## PRODUCT CHANGE NOTIFICATION

#PCN-ICC-4ZKV-14

Change of housing and current bars to achieve 1000Volt applications with suitable solar cables.

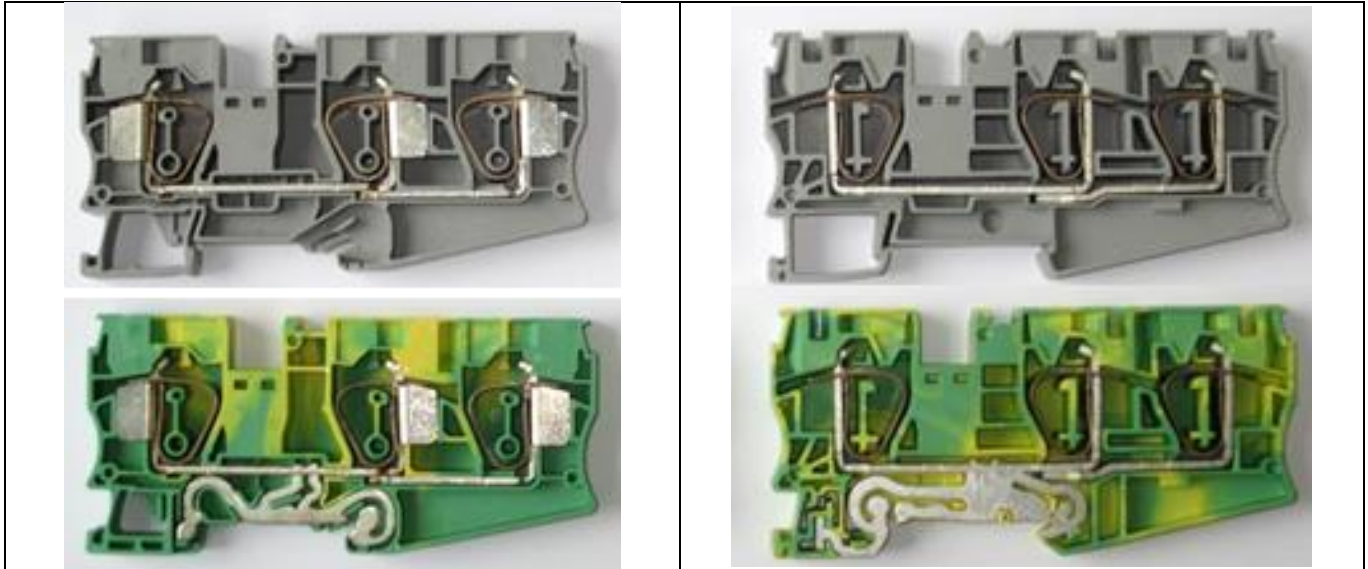
Expanded conductor funnels for standard solar cables up to 11mm outside diameter CLIPLINE accessories as FBS bridges can continue be used.

New Cover D-ST 16-TWIN batch V/C:01 is also needed

The new ST 16-TWIN...-terminals are also UL and CSA approved.
